FINAL ENVIRONMENTAL IMPACT STATEMENT

175-LOT CLUSTER SUBDIVISION APPLICATION

SUMMIT WOODS SUBDIVISION

Town of East Fishkill, Dutchess County, New York

DATE	REVISED	PREPARED BY:
		LEGGETTE, BRASHEARS & GRAHAM, INC.
		Professional Ground-Water and Environmental Engineering Services
		126 Monroe Turnpike
		Trumbull, CT 06611
		(203) 452-3100
DRAWN:	MRV	CHECKED: TPC
		DATE: 7/23/04
		FIGURE: 1

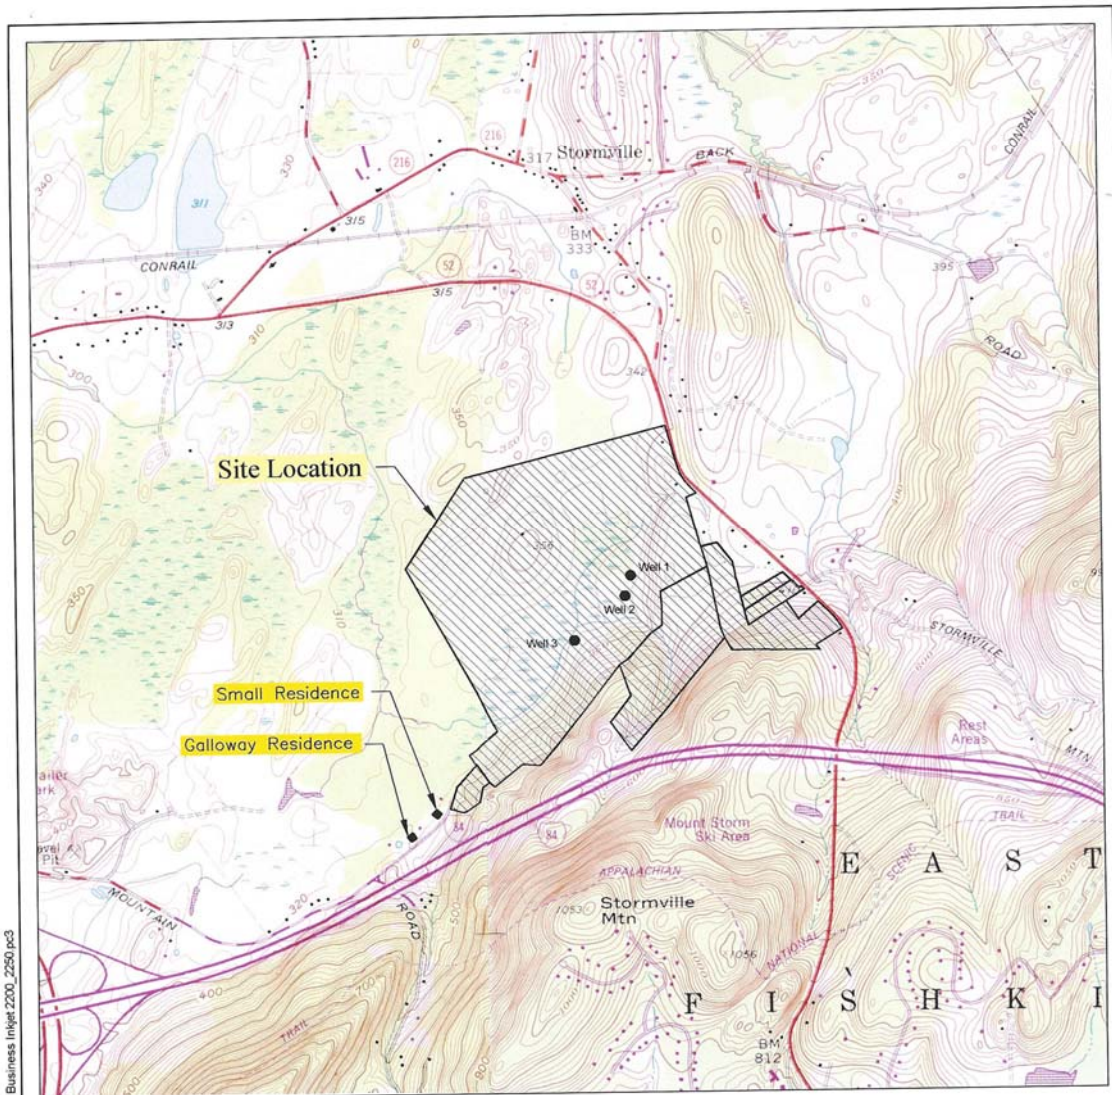
Commentor States: With the addition of 175 homes, how will this impact our water and current well conditions to the residences of Collarbarck Road? We have already been seeing signs of local development, from contamination in our water, the amount of minerals found in our wells and to

the depletion of gallons per minutes being pumped. Comment by Nickita Negersmith in a letter dated February 23, 2004.

Commentor States: I am concerned that the amount of water that will be pumped to supply the development, Summit Woods will impact the water table and adversely affect the water supply of nearby residences. Comment by Katie Galloway in a letter dated February 26, 2004.

As part of the DEIS, a Hydrogeological Study was performed by the office of Leggette, Brashears and Graham. The anticipated impacts were discussed in this study. One of the conclusions of the study states that wells #1 and #3 were pump tested for 72 hours in November 2002 to demonstrate adequate capacity for the Summit Woods project without adverse impacts to neighboring wells. The wells were pumped slightly above the average daily demand required for the site.

See the following page for an excerpt from the LBG report identifying the wells on the Summit Woods project site and the wells monitored as part of the July 2004 well testing. The figure depicts the relationship between the wells on the Summit Woods site and the Galloway and Small wells.

See the previous page of this document for an excerpt from the LBG report identifying the wells on the Summit Woods project site and the wells monitored as part of the July 2004 well testing. The figure depicts the relationship between the wells on the Summit Woods site and the Galloway and Small wells.

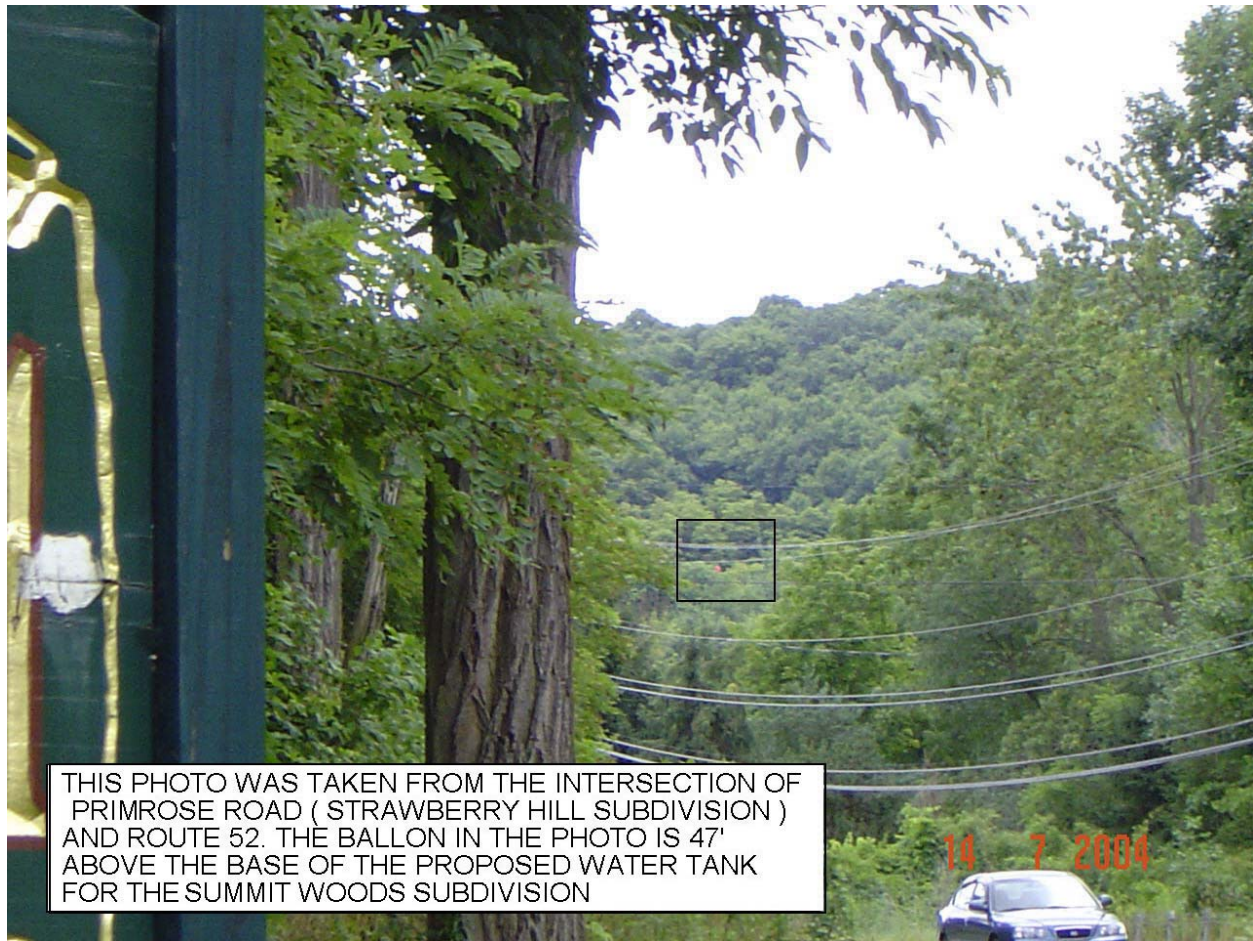
Commentor States: Mr. Koch would like to see photos of the proposed water storage tank on the hill for visual impact from NYS Route 52. Comment made by Mr. Koch at the May 18, 2004, Public Hearing. (Minutes of May 18, 2004, Public Hearing page 16, line 13)
